**NORTHEAST UTILITIES**

February 22, 1983  
Docket No. 50-336  
B10698

Millstone Nuclear Power Station, Unit No. 2  
Request for Additional Information, Measurement Uncertainties  
Response to Question 4

REQUEST FOR ADDITIONAL INFORMATION  
NORTHEAST NUCLEAR ENERGY COMPANY  
MILLSTONE NUCLEAR POWER STATION, UNIT NO. 2  
DOCKET 50-336

FIGURE 3

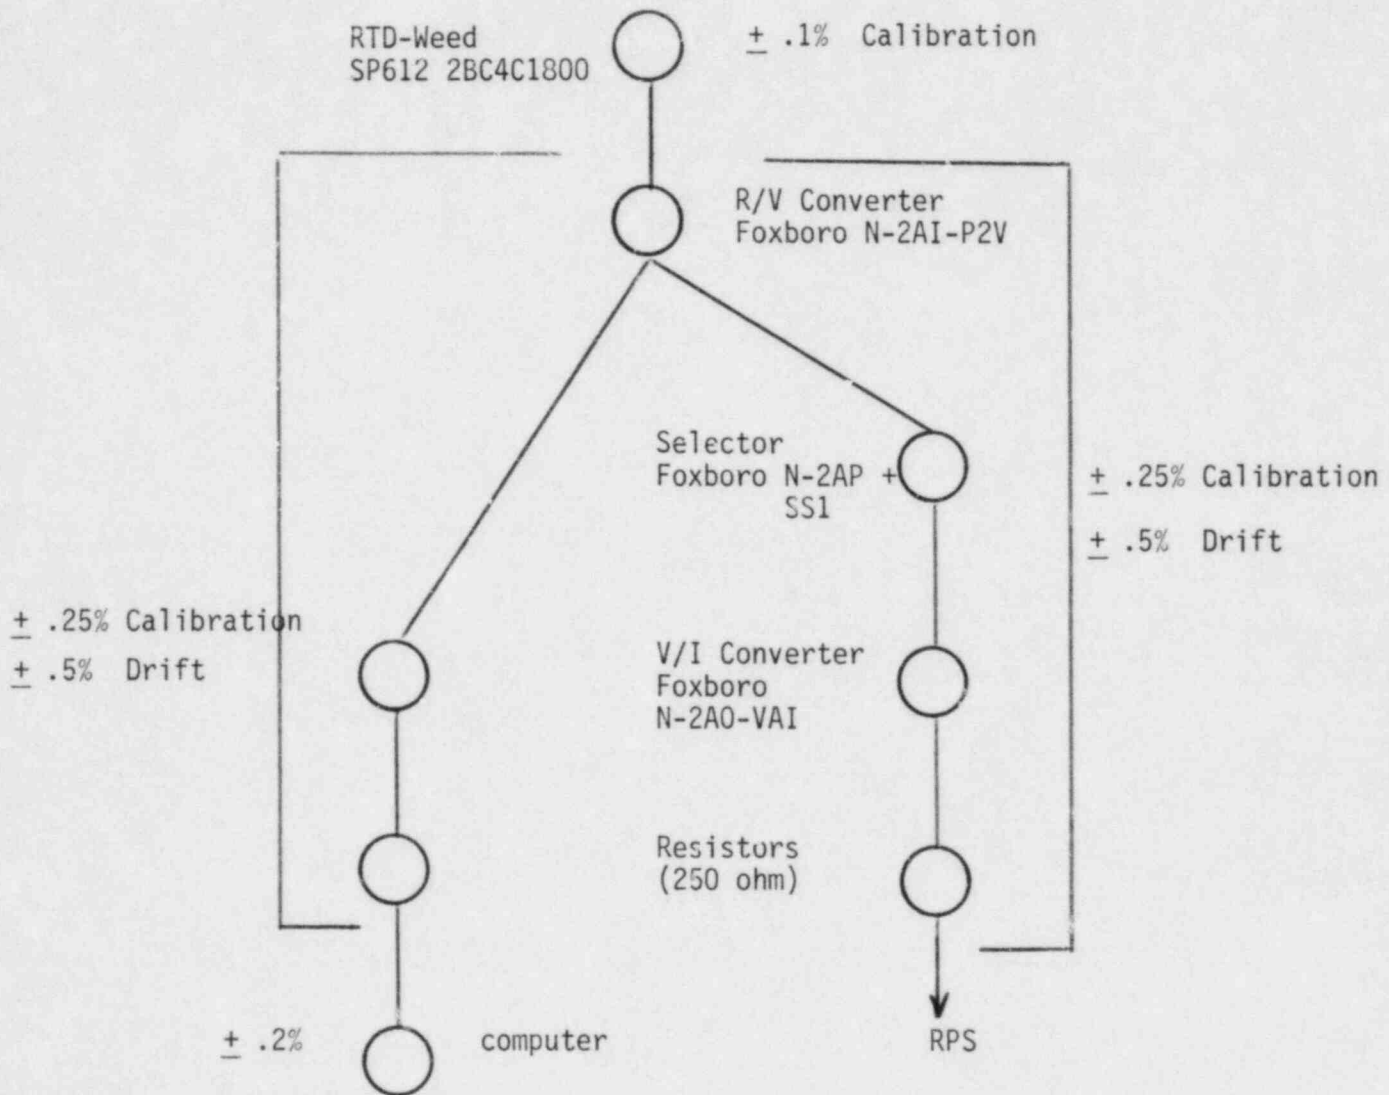
Information is supplied in Appendix A to define instrument span drifts between calibrations. The data supplied are too few to support the assumption of  $2\sigma$  limit. Provide further historical data to confirm the  $2\sigma$  assumption.

Figures 3 and 4 provide the block diagrams for the new primary temperature measurement channels. The primary sensor is a platinum RTD provided by the Weed Instrument Co. The Foxboro SPEC 200 process equipment consists of platinum resistance to voltage (R/V), and V/I converter rack modules. The processed current signal is converted to a voltage signal across a precision 250 ohm resistor which is then provided to either the RPS or to the computer for the primary flow calculation.
